Fremont Urban Apartments

Fremont Urban Apartments
3623 Fremont Ave N
SDCI #:3024574

Design Recommendation

BASEMENT DIAGRAM

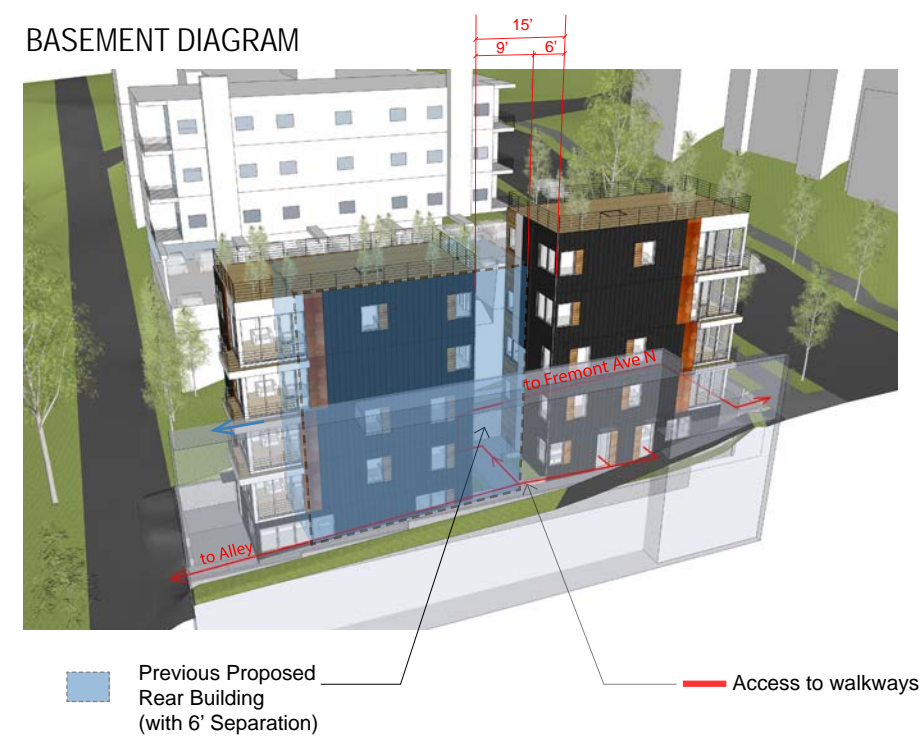
- 3 The Board expressed concern related to the relationship of the proposed massing with adjacent building and requested the following information be included with the next submittal:
- i. Include additional information related to the North and South adjacent building.
 - ii. Provide height diagrams to illustrate impacts to light/air and relationship to adjacent buildings.
 - iii. Provide privacy analysis including relationship of proposed balconies to adjacent structures and window study.
 - iv. The Board discussed the quality of life for the residents of the proposed basements. The Board requested sections illustrating light/air access for basement units and relationship to walkways.

- iv. The diagram below shows how the units on the partially below grade level relate to the pedestrian walkway and amenity area in the courtyard. These units have access to light/air and this was achieved by further separating the buildings. Overall, all of these spaces are shown much more clearly as well in the renderings also, thank you.

DEPARTURE REQUESTS

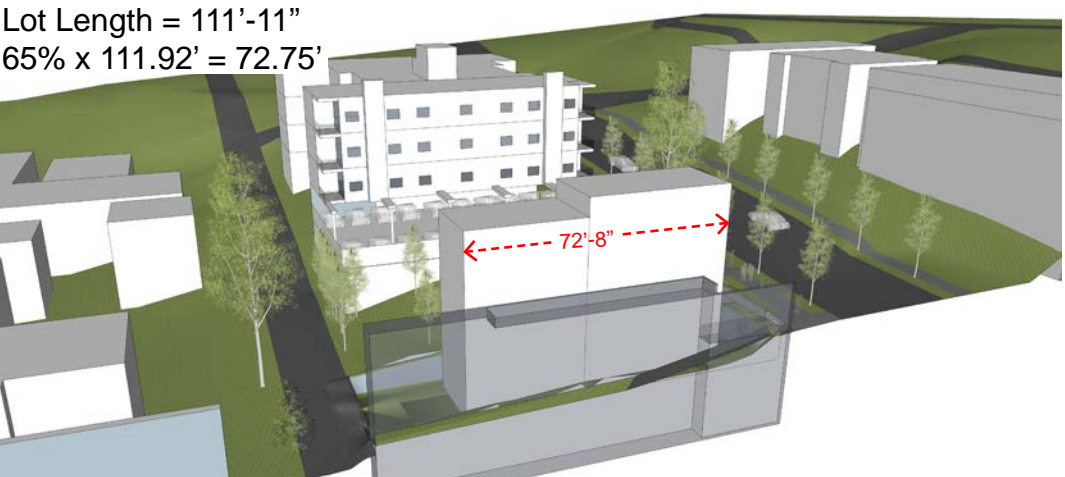
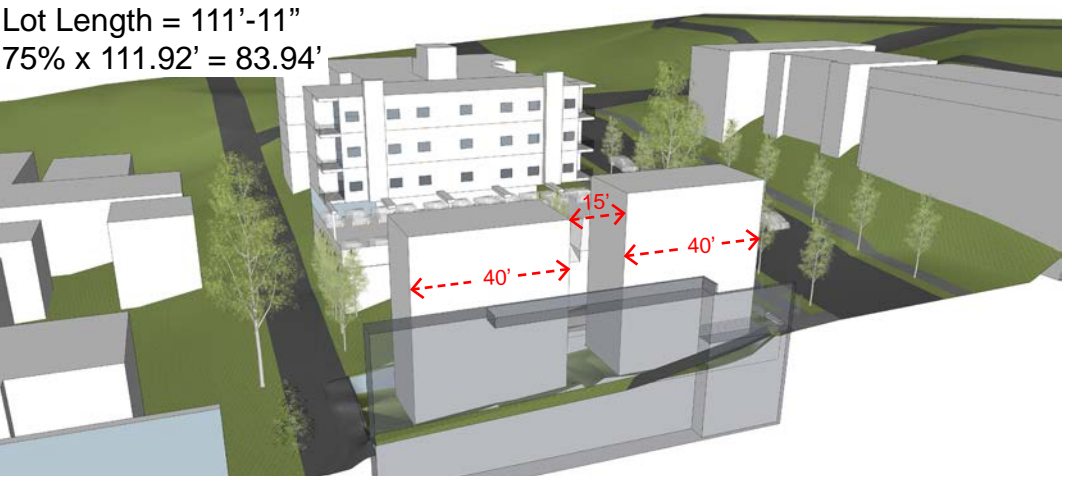
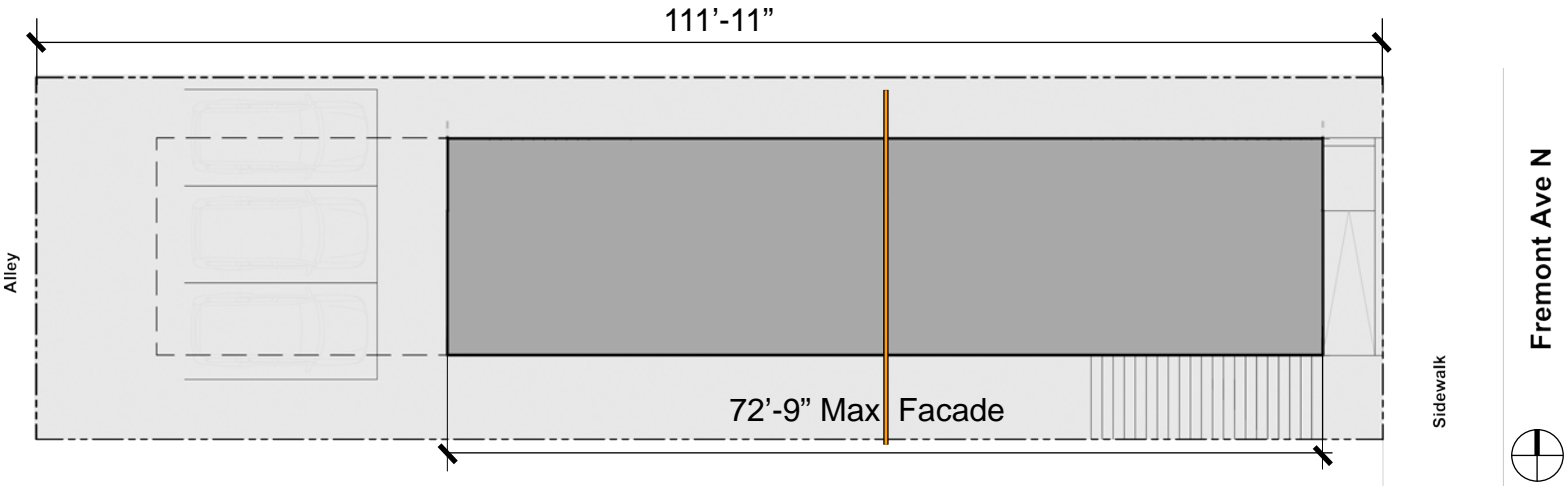
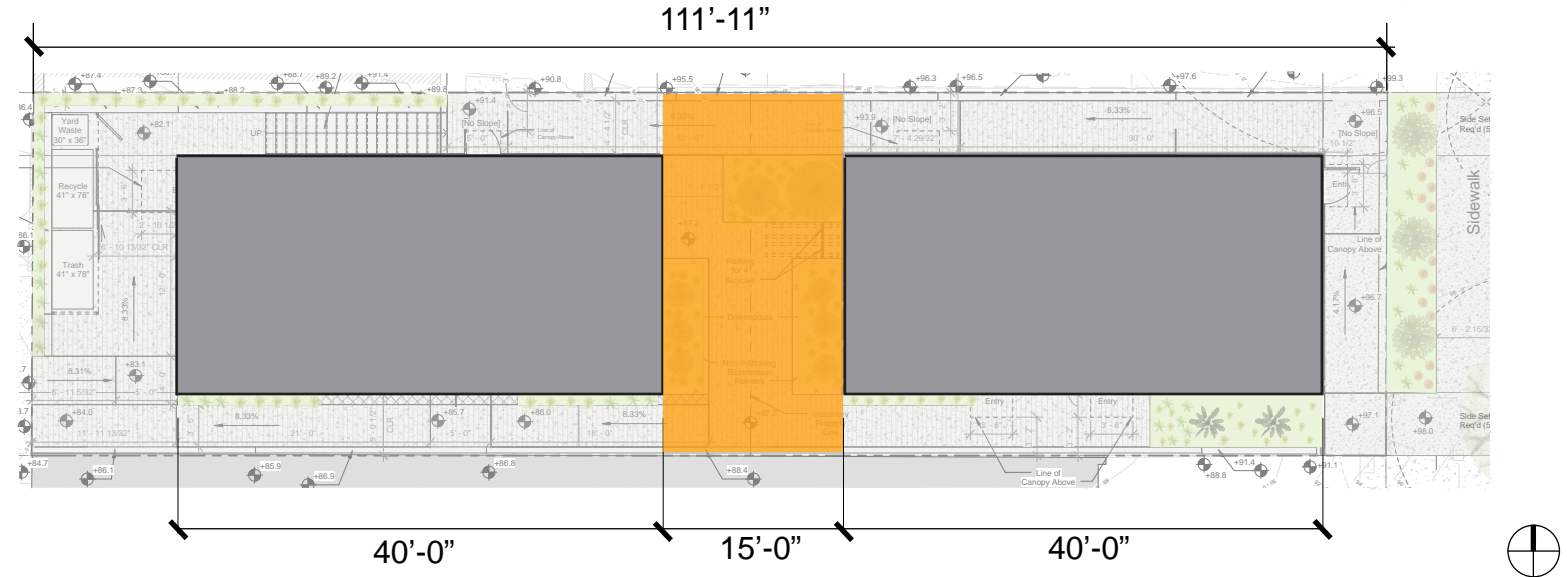
GUIDANCE	RESPONSE	DESIGN GUIDELINES
<p>1 Increase Maximum Facade Length (SMC 23.45.527.B.1): The Code limits the maximum combined length of all portions of façades within 15 feet of a lot line that is neither a rear lot line nor a street or alley lot line to 65 percent of the length of that lot line, except as specified in subsection 23.45.527.B.2. This would result in a permitted length of 72'-8' and the applicant proposes 80'.</p> <p>The Board indicated initial support for this departure, however, a greater gesture toward respecting adjacent sites is needed in order to fully support the departure. The Board encouraged exploration of moving the rear building further back and tucking parking under building, or placing amenity space above.</p>	<p>1 After considering the boards comments, we moved the rear building further back to create a larger, more habitable courtyard between the buildings to greater respect the adjacent sites. The existing building to the South already blocks much of the existing North buildings view, but a much larger area between these 2 buildings will vastly improve access to light, air and views year round.</p>	<p>1 <u>CS1-C - Topography</u> The existing site conditions help inform the design by creating two separate buildings at varying heights to better respect the adjacent sites with more access to natural daylight and air.</p> <p><u>DC3-B - Open Space Uses and Activities</u> A 10% increase to the facade length allows the massing to be separated into two buildings. This reduces the effects to the land, surrounding buildings, and views by allowing more daylight and air within the site.</p> <p>To better respect the neighbors, larger landscaping and amenity areas are provided between the buildings. Each resident will have access to this common amenity and a portion of the residents will have access to private amenities area on the roof deck.</p>

#	Departure Request	Code Requirements	Explanation for Departure
1.	Requesting departure to increase maximum facade length by 10%	23.45.527.B.1: The maximum combined length of all portions of façades within 15 feet of a lot line that is neither a rear lot line nor a street or alley lot line shall not exceed 65 percent of the length of that lot line, except as specified in subsection 23.45.527.B.2.	An increase to the facade length by 10% allows for a massing separation into two buildings to help minimize effects to the land, surrounding buildings, and views. (CS1-C) After considering the Board's comments from the EDG meeting, we moved the rear building further back to allow for landscaping, amenity areas, and natural light between the buildings. (DC3-B)

No Departures: Max Facade length at 72'-8"

Departures: Max Facade Length at 83'-11"

LIGHTING PLAN

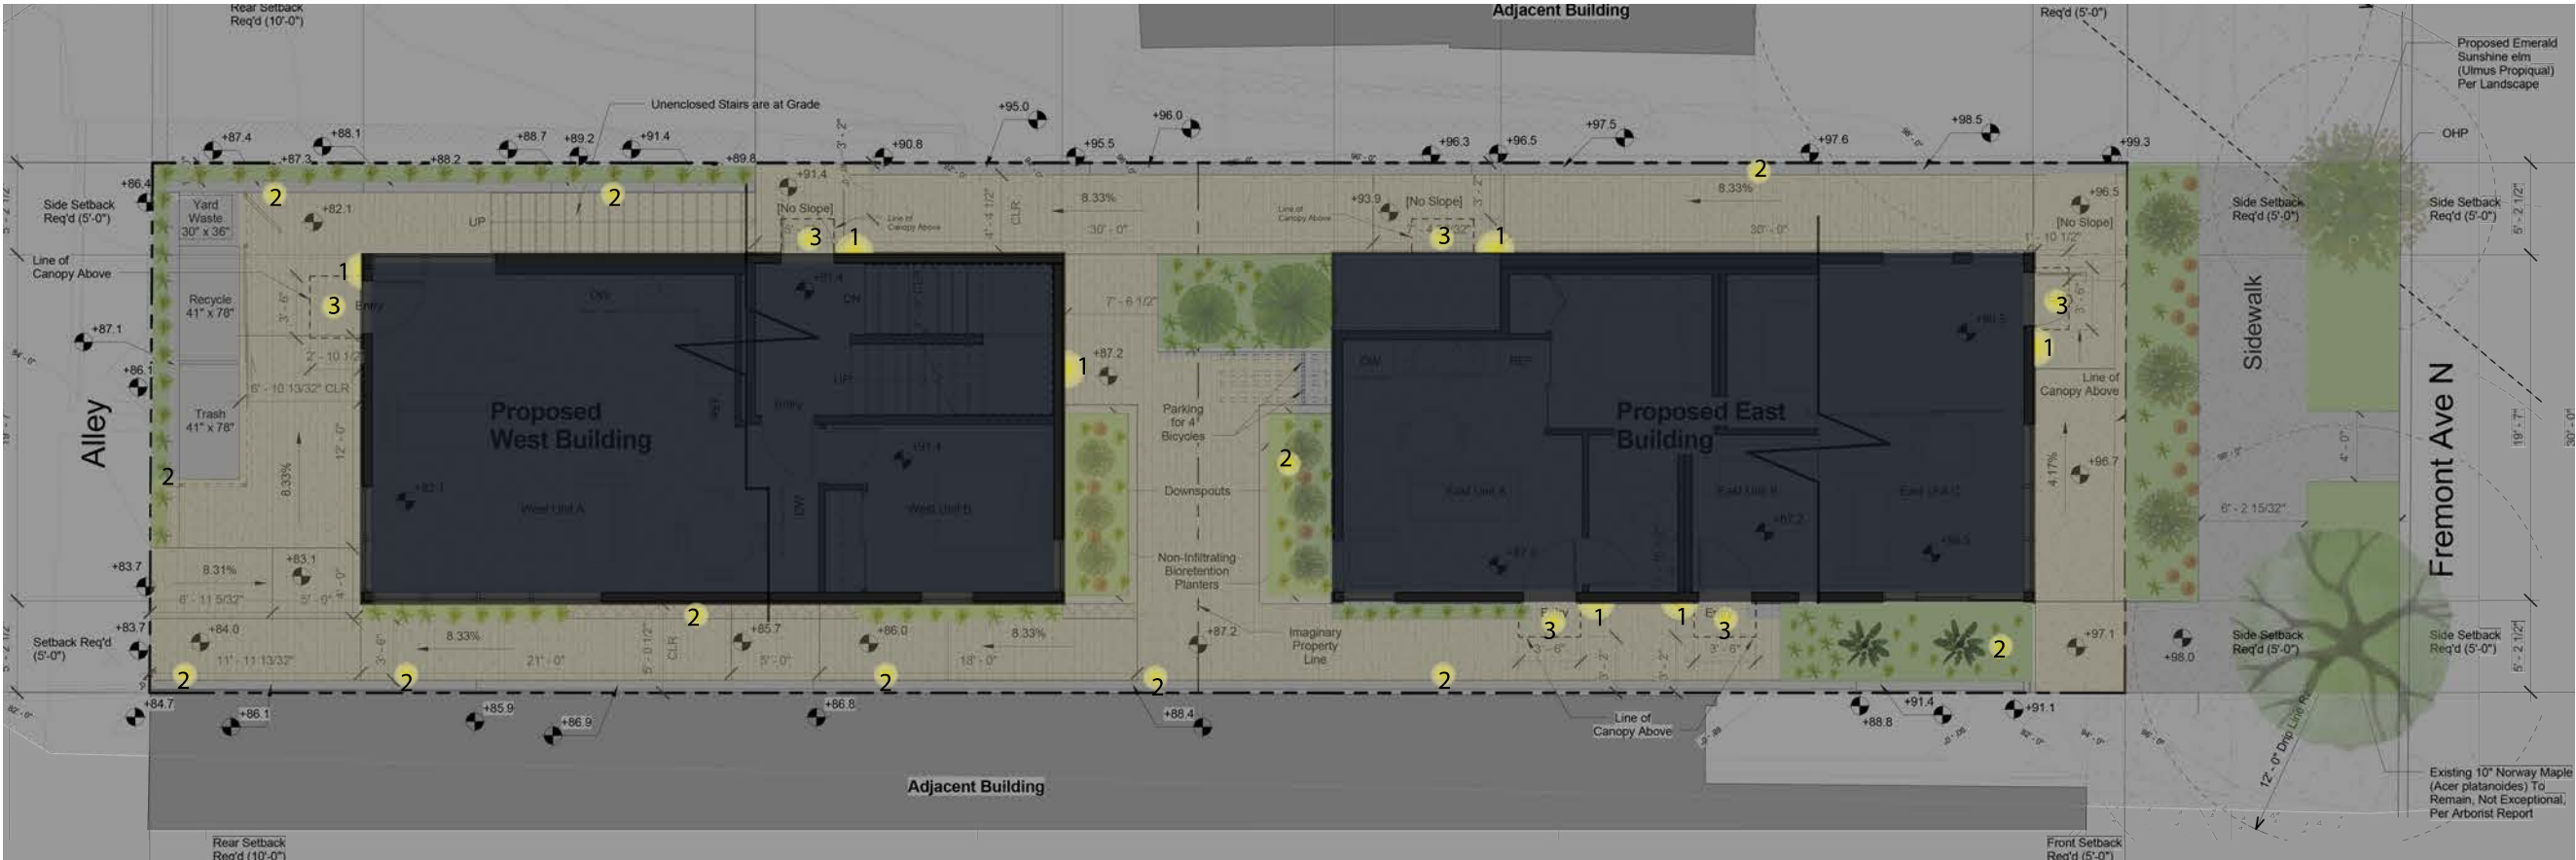
<p>5 Provide lighting plan and more information on the design that will deter crime and gathering in the narrow corridors.</p>	<p>5 A lighting plan on page 49 shows how this project will achieve safety and security for residents. The open stairs haven been enclosed for additional security. These market rate apartments in a high quality building will not generate crime. Residents go through an extensive application process for these long term leases. Pathways for residents and guests help to generate better open space that will be actively utilized by all and maintained by building management.</p>	<p>5 PL2-B - Safety and Security The lighting plan illustrates safe, well-lit pathways complimented with natural landscaping to provide safety for residents and neighbors.</p>
